Access Compliance Report

Public Rights-of-Way

Intersection ID: 14706	Main Street: FULLIGER_ST	Cross Street: HIRAM_ST	Location: NW
ADA ID: 3BBFA7291737	Ramp Type: BlendTrans1	Initial Pass/Fail: Fail	Overall Compliance: No
		Severity Score: 10

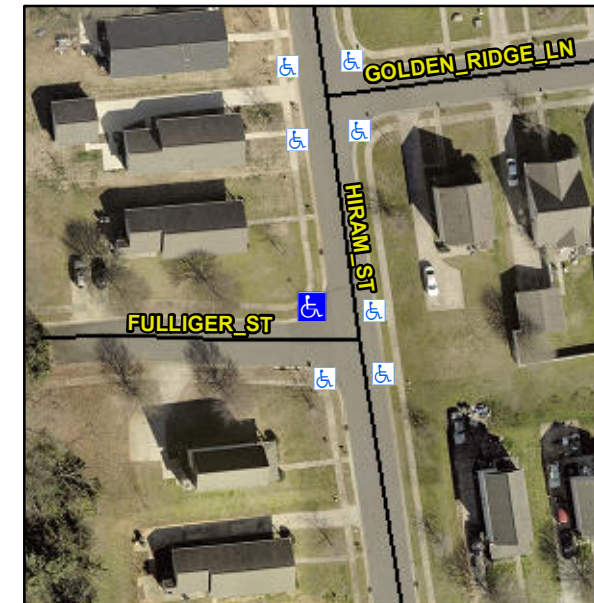
Not Found, R304.5.1, R304.5.3

Compliance	Description	Data	Compliance	Description	Data
N/A	Ramp Length (in)	54.0	Yes	BlendTrans Slope (%)	3.1
No	Ramp Width (in)	42.0	No	BlendTrans XSlope (%)	2.3
N/A	Flare Type LT	N/A	N/A	Flare Type RT	N/A
N/A	Flare Slope LT (%)	N/A	N/A	Flare Slope RT (%)	N/A
N/A	Flare Traversable LT?	N/A	N/A	Flare Traversable RT?	N/A
N/A	Landing Length (in)	N/A	N/A	DWS Provided?	N/A
N/A	Landing Width (in)	N/A	N/A	DWS Contrast?	N/A
N/A	Landing Slope (%)	N/A	N/A	DWS Length (in)	N/A
N/A	Landing X Slope (%)	N/A	N/A	DWS Full Width?	N/A
N/A	Landing Curb? (Y/N)	N/A	N/A	DWS Offset (in)	N/A
N/A	Shared Landing?	N/A			
N/A	Gutter Ponding?	N/A	N/A	Gutter Slope (%)	N/A
N/A	Gutter Lip Ht (in)	N/A	N/A	Gutter X Slope (%)	N/A
N/A	Painted X Walk1?	No	N/A	Painted X Walk2?	No
	X Walk 1 Direction	To E		X Walk 2 Direction	To S
	X Walk 1 Width (in)	N/A		X Walk 2 Width (in)	N/A
	X Walk 1 Slope (%)	3.7		X Walk 2 Slope (%)	2.5
	X Walk 1 X Slope (%)	2.1		X Walk 2 X Slope (%)	7.0

N/A	Ramp inside XWalk1?	N/A	N/A	Ramp inside XWalk2?	N/A
	Road Slope (%)	2.0		Clear Space?	N/A
	Road X Slope (%)	3.3	N/A	Clear Space to XWalk (in)	N/A
N/A	Any Obstructions?	N/A	N/A	Storm Grate/Utility Hazard?	N/A
	Obstruction Type			Storm Grate/Utility Type	
		N/A			N/A
			Yes	Surface Condition? (G/P)	Good
			No	Curb Slope (%)	9.7

Remove & Replace Curb Ramp With Two New Directional Ramps or Equivalent.
